AMENDMENT NO. 1 JANUARY 2023

IS 208 : 2020 DOOR HANDLES — SPECIFICATION (Sixth Revision)

FIG. 4 TYPICAL DOOR HANDLE (TYPE 4)

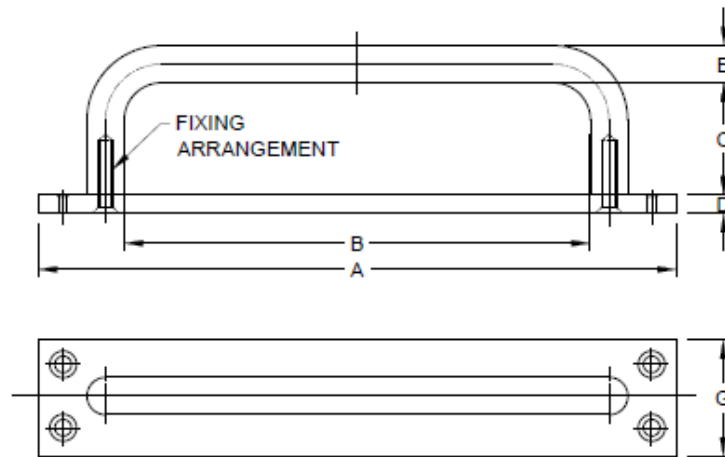
(Page 3, Fig. 4) — Substitute the following for the existing figure:

NOTE — M5 × 20 mm GI Countersunk machine screw or any other suitable fixing arrangement may be used

FIG. 5 TYPICAL DOOR HANDLE (TYPE 4)

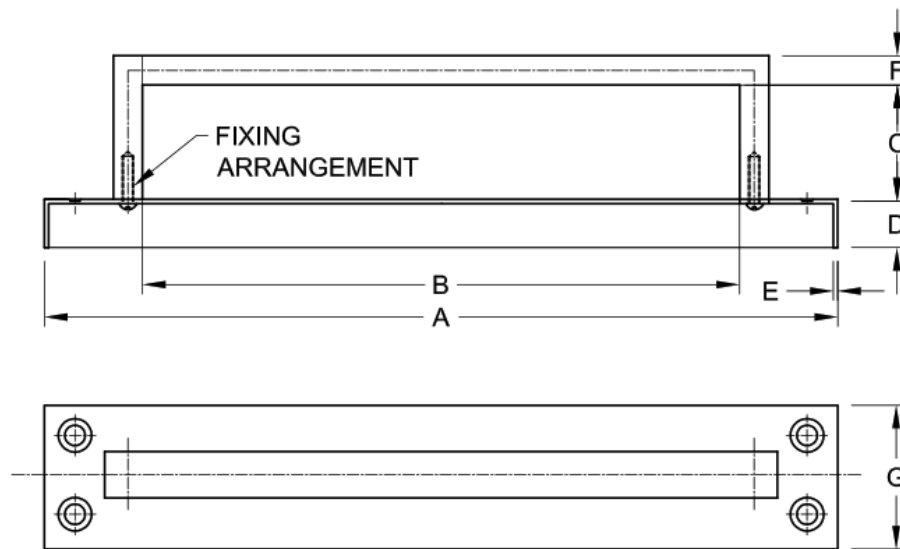
(Page 7, Fig. 5) — Substitute the following for the existing figure:

NOTE — M5 × 15 mm SS machine screw or any other suitable fixing arrangement may be used
